October 2018

# **ENVIRONMENT AND CLIMATE CHANGE CANADA (ECCC)**

# CROWN-INDIGENOUS RELATIONS AND NORTHERN AFFAIRS CANADA (CIRNAC)

(source: FEIS Appendix 5-E, Section 3.3.1, Figure 9)

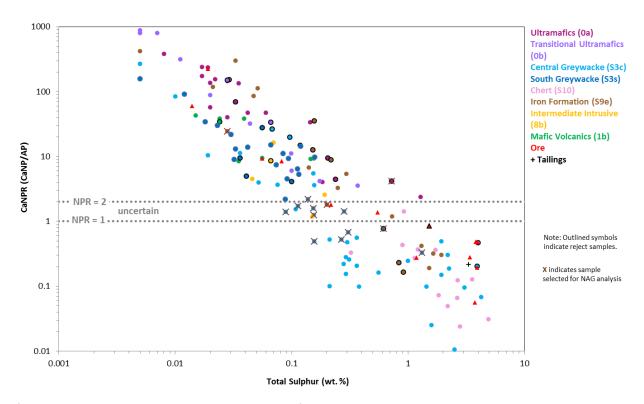
CIRNAC recommends that the suitability of using the 0.1 wt% sulfur as threshold be substantiated with data and analysis before it could be applied.

The proposed sulfur threshold is indeed substantiated with analytical data. Figure 9 (copied below) in Sections 3.3.1 of the FEIS Appendix 5-E (Agnico Eagle, 2016) provides a comparison of % S, carbonate neutralization potential (carbonate minerals are the main source of neutralization) and MEND (2009) guideline for ARD classification. The figure illustrates that samples that have a sulphur content less than 0.1 wt% are non PAG based on their ratio of Carbonate neutralisation potential ratio. As such, the sulfur content is not the only means by which ARD potential is being assessed but happens to identify an appropriate cutoff below which all samples are NPAG according to MEND (2009).

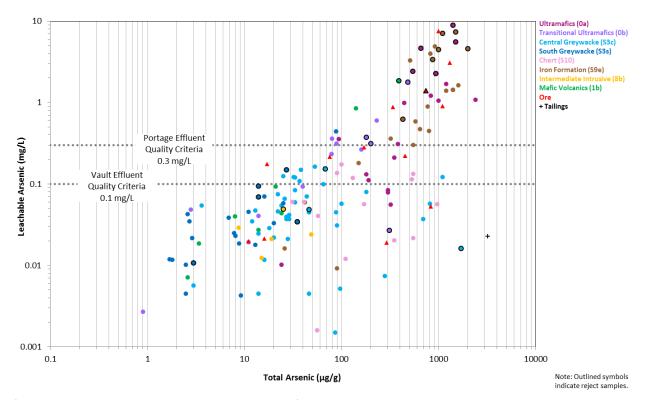
The Plan states that "Arsenic leaching material will be evaluated based on a strong correlation between total and leachable arsenic in the current results, which indicates that material below 75 mg/kg is not expected to result in waste rock contact water quality above the EQC." CIRNAC notes the absence of data to substantiate the above claim.

The proposed total arsenic content threshold proxy for leachable arsenic is substantiated with analytical data on chemical composition, static and kinetic leaching test data. The proxy arsenic value is used per the ARD-ML Sampling and Testing Plan which has been approved in the Project Certificate and the Water License.

# ARD/ML Plan Attachment B: Flow Chart

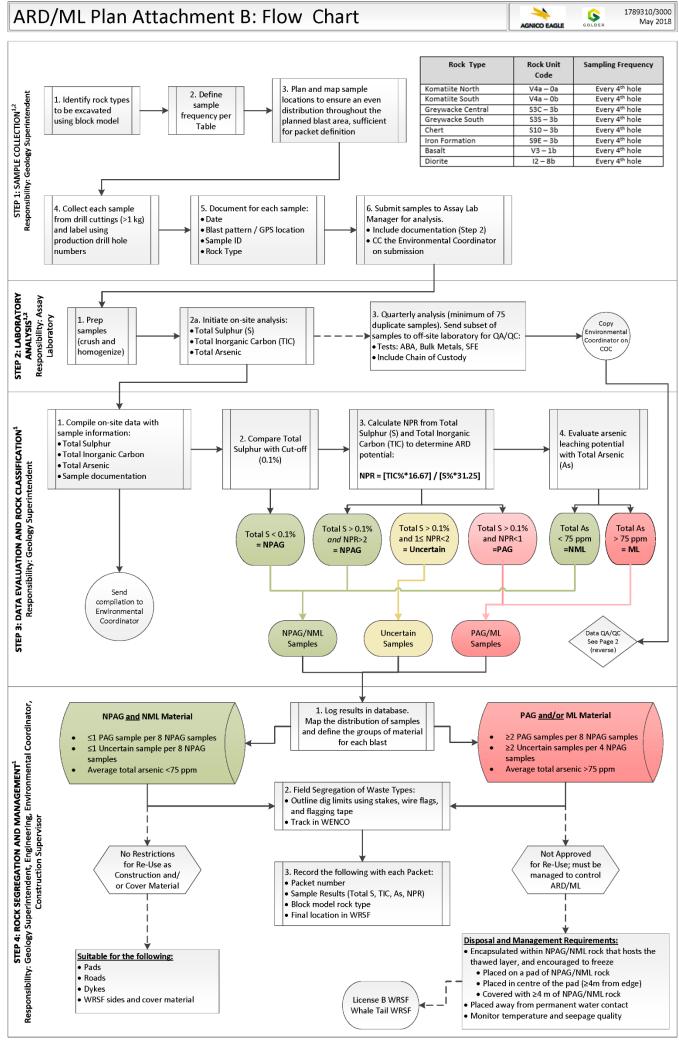
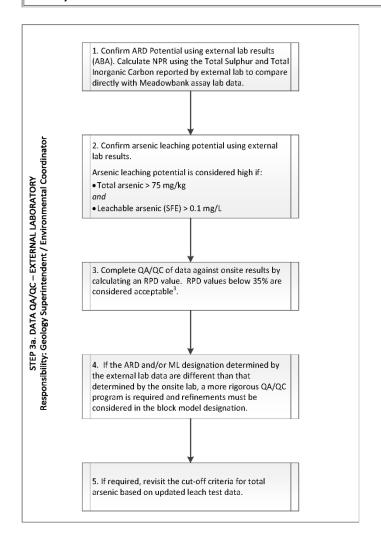
CIRNAC recommends that specific details be included to make the plan implementable.

Agnico Eagle does not agree with this recommendation and refers CIRNAC to the ARD-ML Sampling and Testing Plan Appendix B "Flow Chart for Waste Rock delineation and segregation" shown below. Step 4: Rock segregation and management gives implementable details on how the two (2) different types of waste (i.e. NPAG and NML and PAG and/or ML) will be disposed of during Operations. Agnico Eagle would like to clarify that waste rock segregation is not based only on rock type or lithology but rather on operational ARD-ML testing results.
